STAFF REPORT

<u>CASE NUMBER:</u>	S/D 90-13 - EAST SUBSTATION ADDITION
<u>OWNER/APPLICANT:</u>	City of Wichita
<u>SURVEYOR/ENGINEER:</u>	Baughman Company
<u>LOCATION:</u>	South of Harry St. in an area east of Woodlawn
<u>SITE SIZE:</u>	25.5 Acres
<u>NUMBER OF LOTS</u>	
Residential:	
Office:	
Commercial:	1
Industrial:	
Total:	1
<u>MINIMUM LOT AREA:</u>	756,678 sq. ft.
<u>CURRENT ZONING:</u>	"C" Commercial (DR 90-6)

Re: S/D 90-13 EAST SUBSTATION ADDITION

EAST SUBSTATION ADDITION

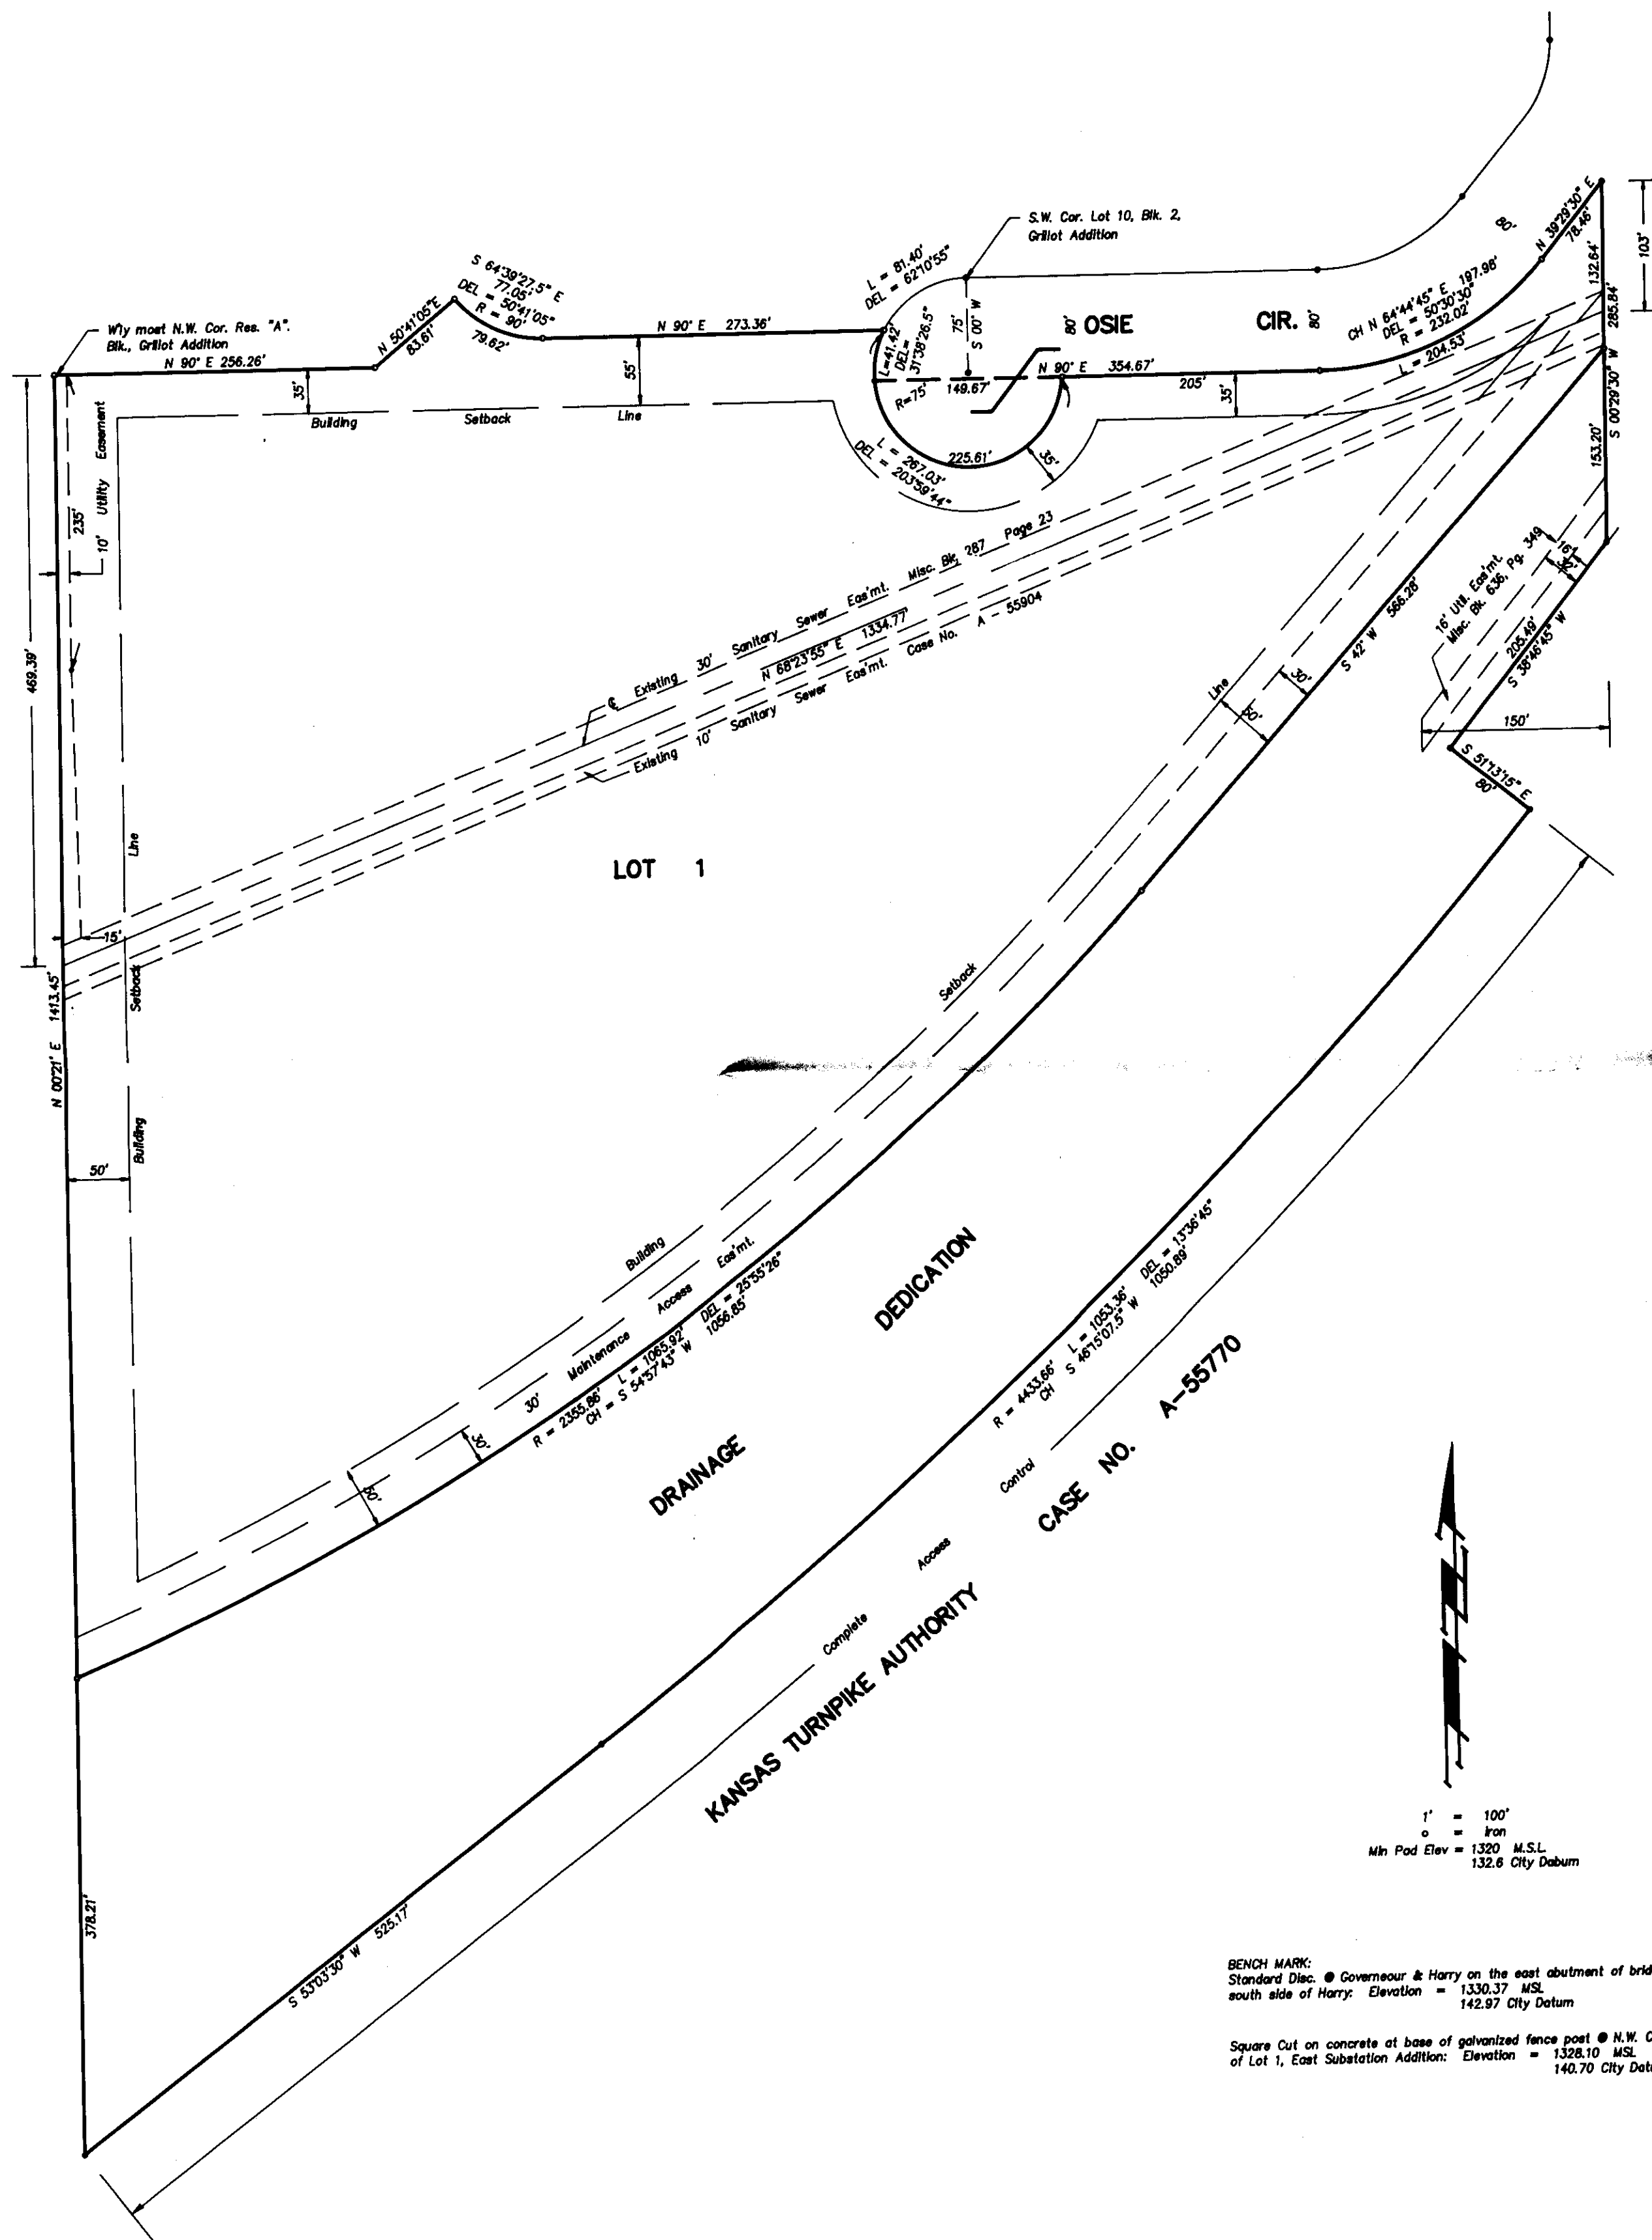
- A. The applicant shall provide for any drainage improvements required by the platting of this property. These guarantees may be included with the paving guarantees.

- B. The applicant shall provide for the paving of the interior street (Osie/Gouverneur from Harry) and the cul-de-sac required for the proper termination of Osie Circle.

- D. Since this plat is proposing the vacation of a portion of the south half of Osie, abutting property owners to the north should also consent in the vacation. The applicant shall therefore attempt to get the owners of Lot 1, Grillot 3rd and lots 11 and 12, Grillot Addition to sign a separate vacation application for the north half of Osie. As part of the vacation, the owner of Lot 12, who is also the owner of Lot 2, Grillot Addition should be required to submit a covenant requiring that these two lots not be sold separately. The covenant is necessary since Lot 12 will no longer have access to a public street. If such a covenant cannot be obtained the City by separate instrument should establish an access easement to the benefit of Lot 12, Grillot Addition which would allow access to Osie Circle.

- E. Since the tie point for this plat is referenced to a previously platted lot corner, the engineer's text shall reference the quarter section in which the plat is located. Section 5-402(D)(3).

- F. The applicant shall submit an avigational easement covering all of subject plat and a restrictive covenant assuring that adequate construction methods will be used to minimize the effects of noise pollution in the habitable structures constructed on subject property.

- G. The final plat tracing shall indicate utility easements for the planned storm water sewer and existing sanitary sewer along this plat's east line. Also, the plat tracing shall indicate the utility easements requested by Southwestern Bell Telephone and indicated on the enclosed marked copy of the plat.
